Subject: Duke Energy Corporation
Oconee Nuclear Station - Units 1, 2, and 3
Docket Nos. 50-269, 50-270, and 50-287

Revisions to Topical Reports DPC-NE-3000 and 3005 In
Support of Steam Generator Replacement
Response to NRC Staff Request for Additional
Information

**Duke Power Response To
Request for Additional Information Regarding Topical Reports
DPC-NE-3000 Revision 3
“Thermal-Hydraulic Transient Analysis Methodology”
and
DPC-NE-3005, Revision 2
“UFSAR Chapter 15 Transient and Accident Methodology”**

Revised DPC-NE-3005-P Chapter 15 - Steam Line Break

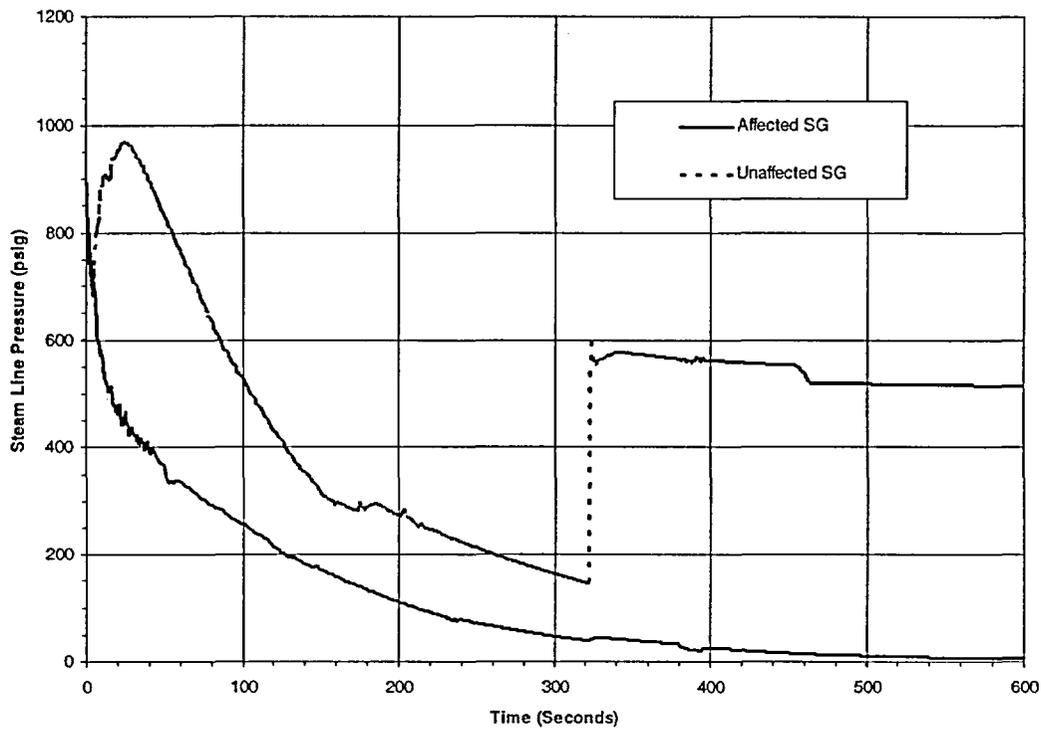
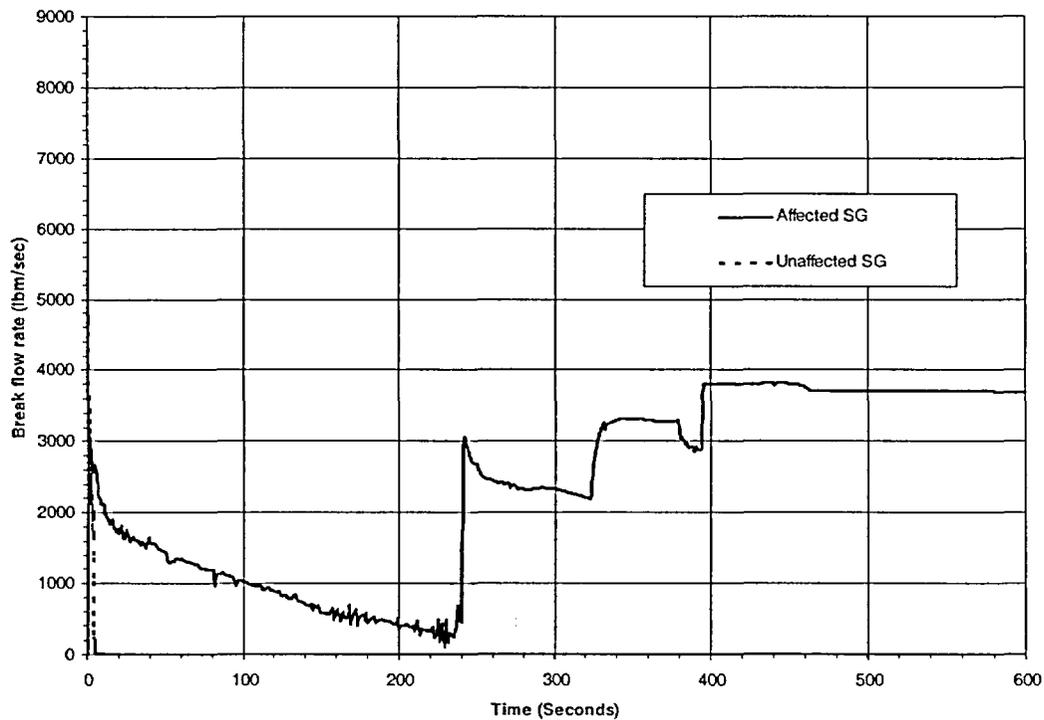
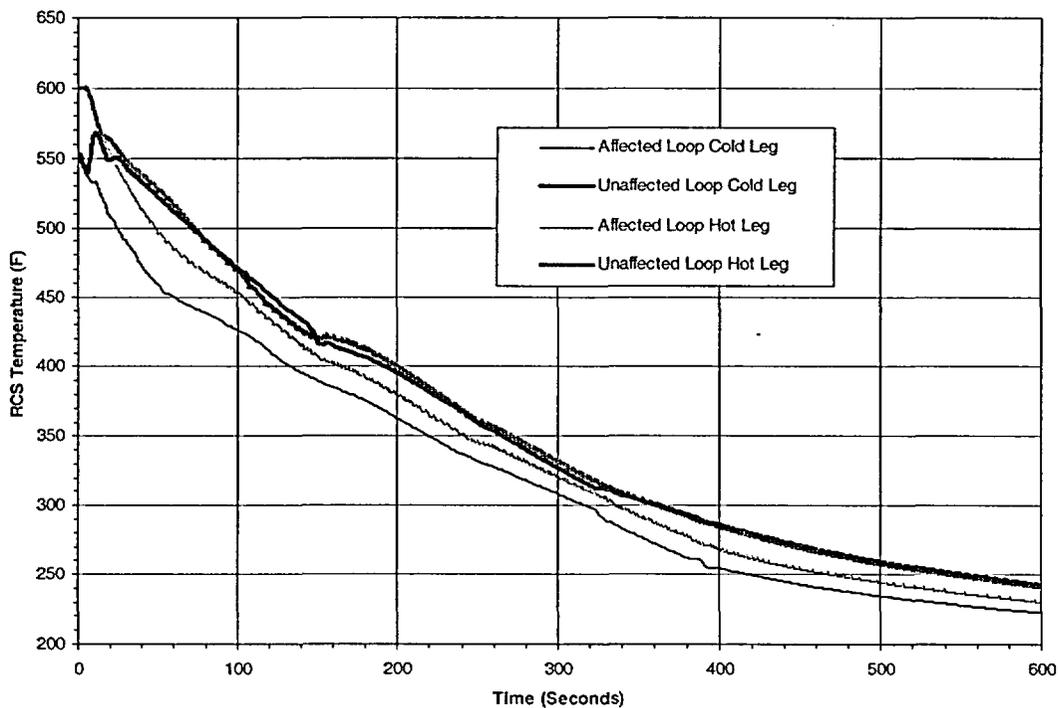
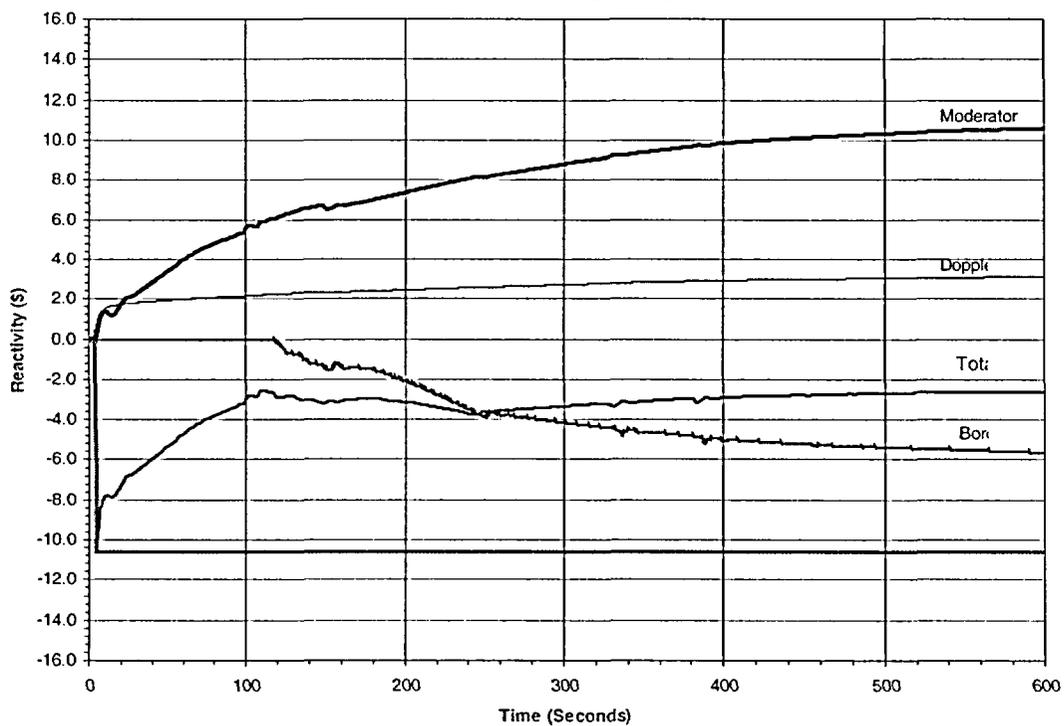
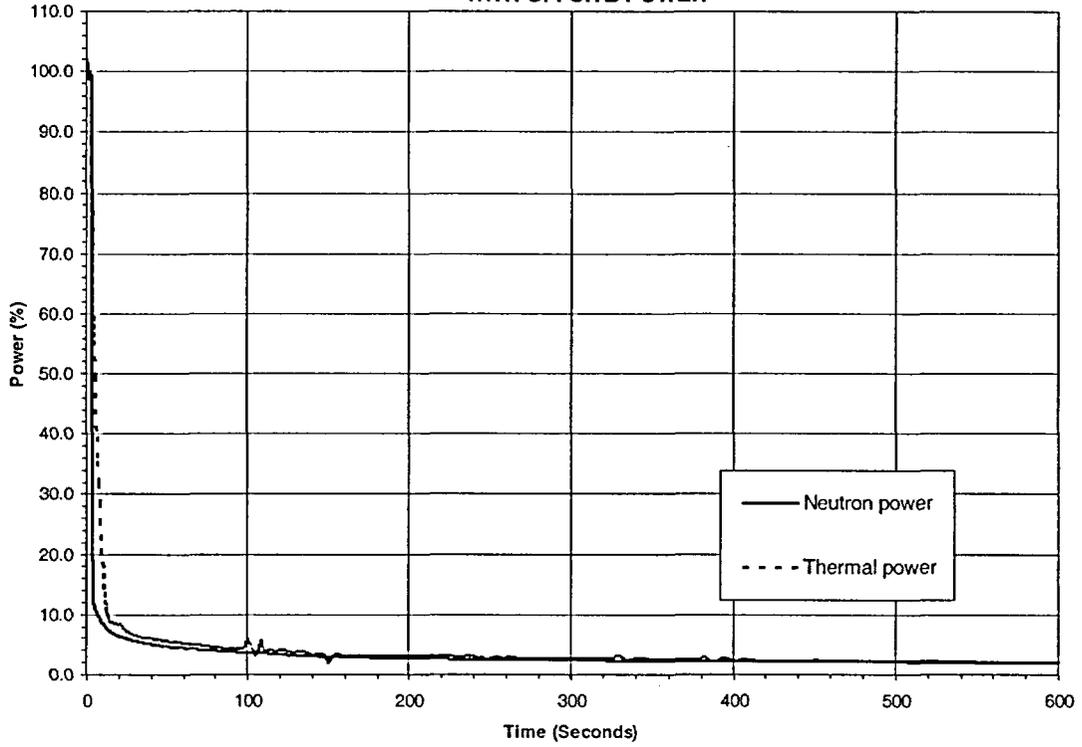
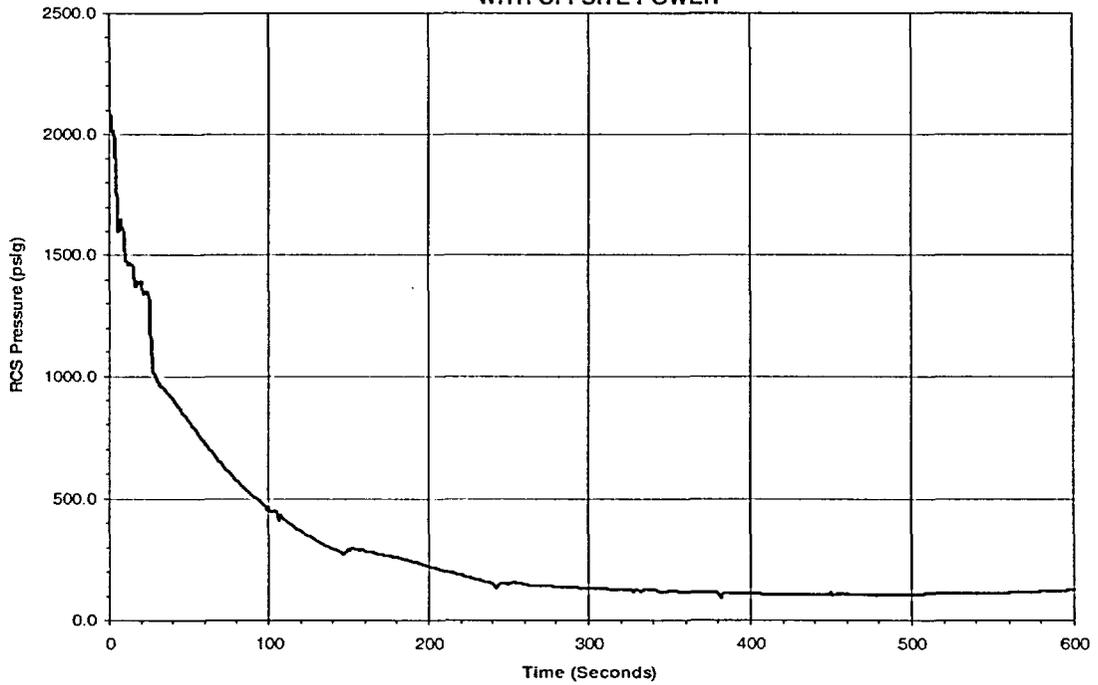
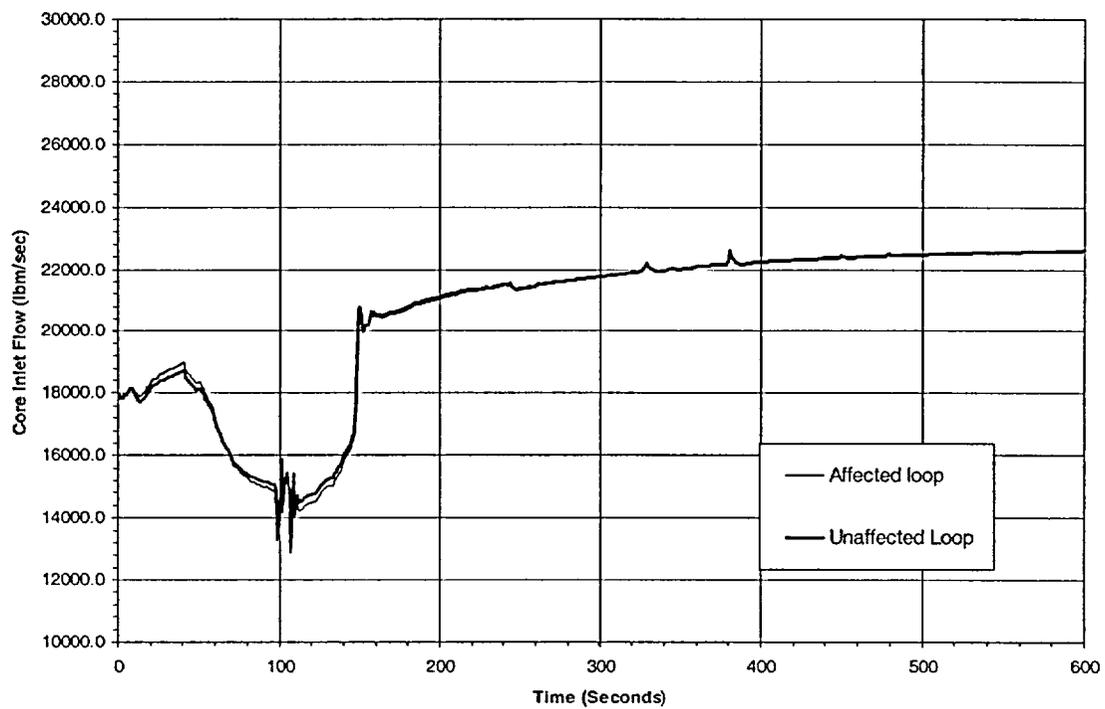
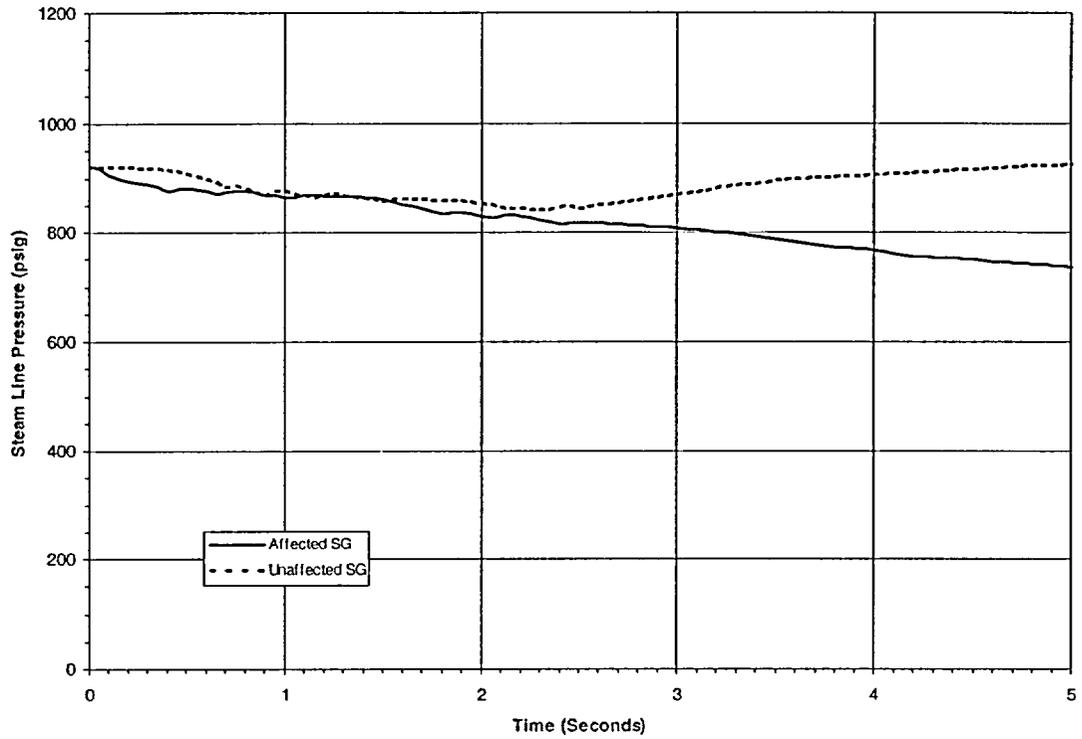
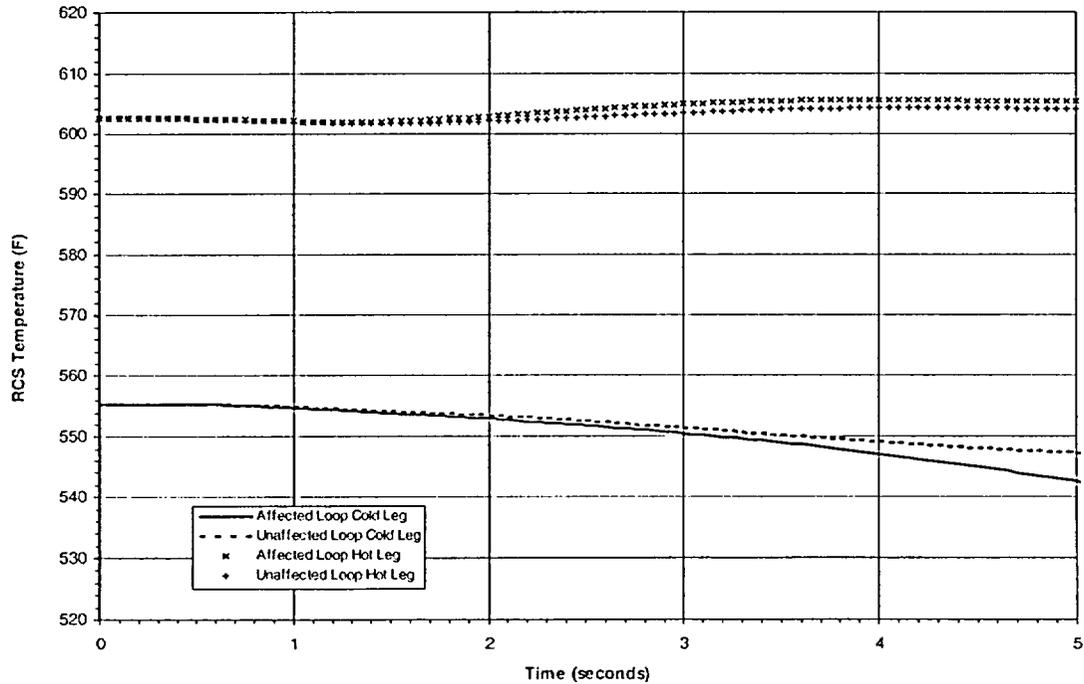
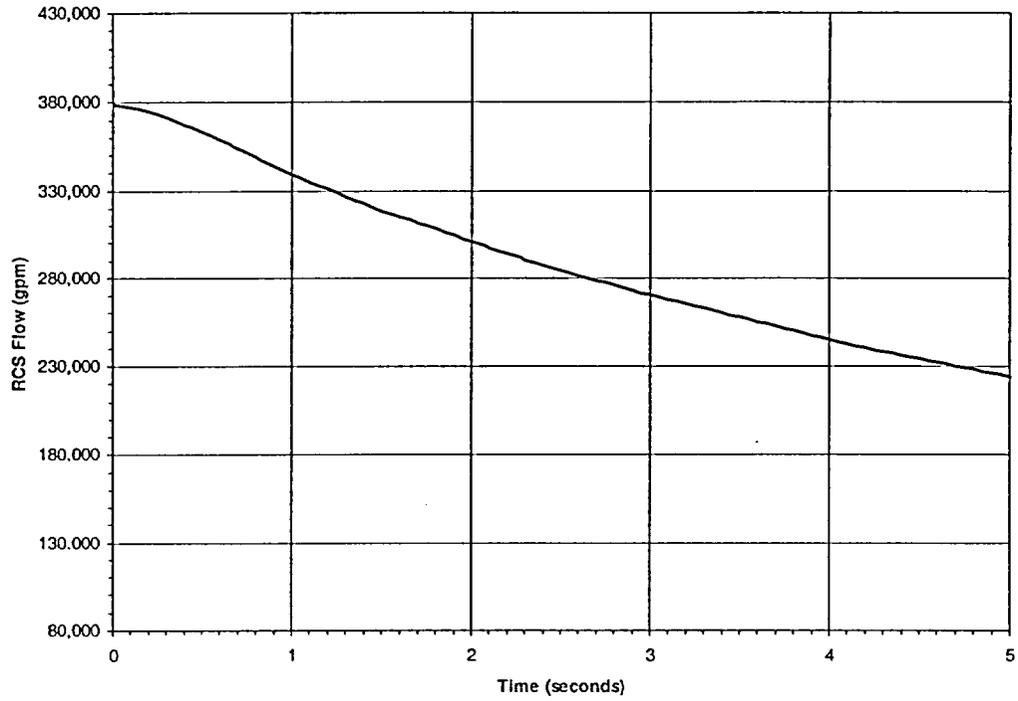
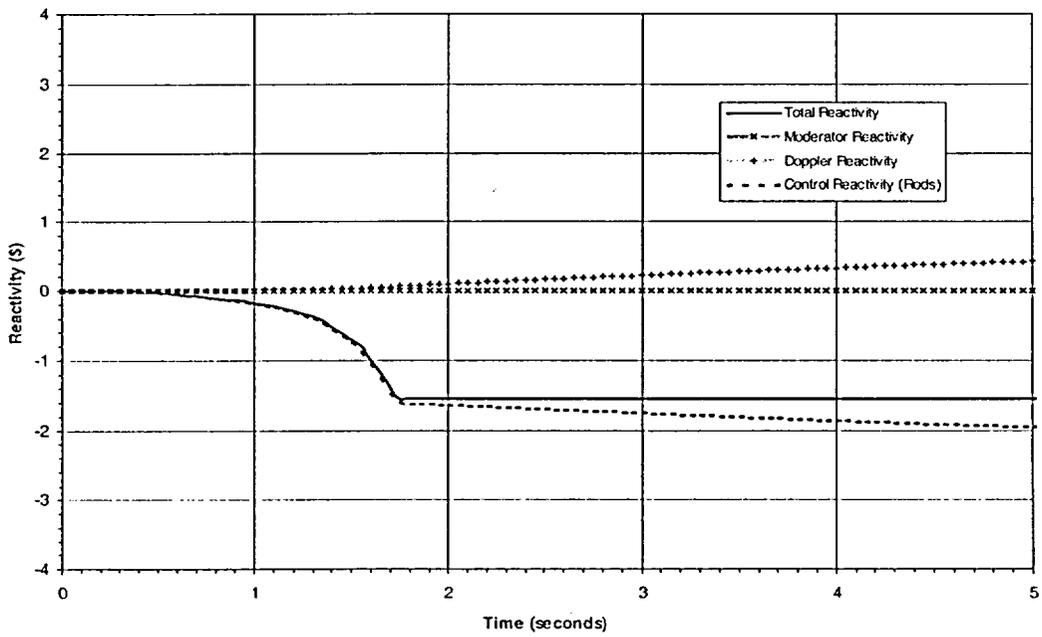
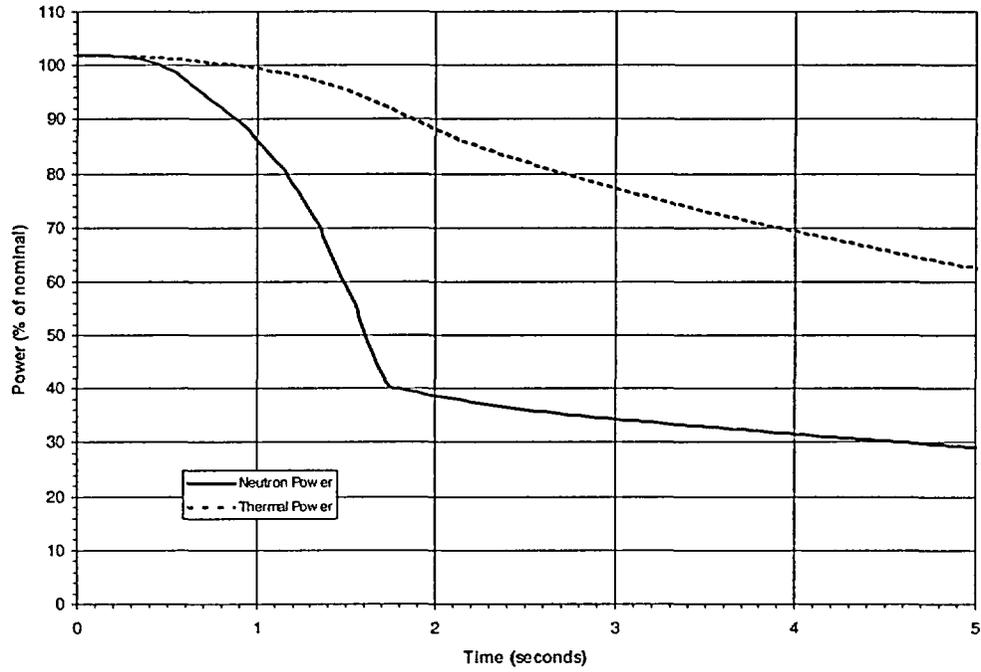
24. Page 5-36 to the revisions to DPC-NE-3005-PA states that the only significant difference between the transient thermal-hydraulic behavior with the new steam generators will be for the main steam line break analysis, in which the flow restriction orifices in the outlet nozzles will effectively reduce the minimum break size and blowdown rate. In addition the new steam generators will have a greater heat transfer area and a greater water mass. Differences in calculational models between RETRAN-02 and RETRAN-3D may also affect the result. In particular assumptions for phase separation within the steam generators and steam flow rate from the break may affect the result. Please provide main steam line break analyses similar to those in Chapter 15 of DPC-NE-3005-P for cases both with and without offsite power for the new steam generators with RETRAN-3D.

Response: The revised topical report text and figures (included after the response to Question 29) show the RETRAN-3D main steam line break analysis results for both with and without offsite power with the replacement steam generators. A brief summary of the result of the analyses is as follows. The steam outlet nozzle flow restrictors cause a slower RCS cooldown and depressurization rate, which provide more favorable results. For the with offsite power case the slower cooldown rate does not result in a loss of the subcritical margin according to the RETRAN-3D and SIMULATE simulations. Consequently, no detailed core thermal-hydraulic analysis was performed. For the without offsite power case, the RCS depressurization rate is slower, and the statepoint at the time of minimum DNBR is more favorable. Consequently an increase in DNBR margin is gained relative to the previous RETRAN-02 OTSG analyses.
